## Duraflex Introduces New eZee Fit Bead

**NEW 5863 'eZee' Bead - 28mm**

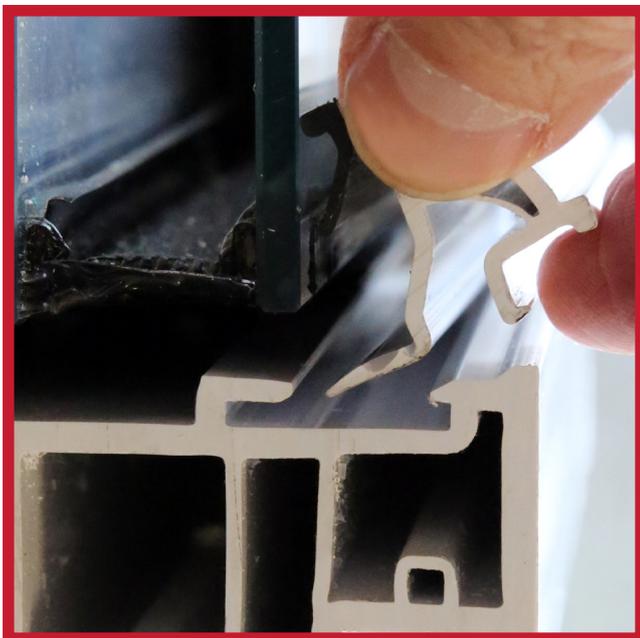
Both aesthetics and performance have been meticulously designed to ensure the featured detail replicates your current bead (5850) and suites seamlessly with existing installations.

Furthermore, the new eZee Bead **passes and exceeds the enhanced security accreditation (PAS24) and Secured by Design without the use of security clips**, reducing both fabrication and installation time, as well as additional costs. These enhanced security credentials makes the eZee Bead one of the most secure beads on the market today, improving the security and peace of mind for your customers.

<b>FEATURES</b>	<b>BENEFITS</b>
Longer Front Leg on Bead	Locates Easily into Bead Pocket
Chamfered Front Bead Leg	Allows Bead Leg to Glide into Pocket
Clip Detail on Back Leg	Locks into Frame for High Security
Beads Tighter in Un-glazed Frames	Beads Not Lost in Transit
Butt/Scribed Finish	Easy to Fit
Bead Sits Tight in Glazed Frame	No Gaps in the Corners, Perfect Fit
Ease of Fitting Bead	Speeds up Installation
Installer Friendly	Easy Choice for all Trades & Skill Levels
Enhanced Security Performance	PAS24 and Secured by Design Compliant
No Need for Glass Clips	Save Time and Reduce Costs
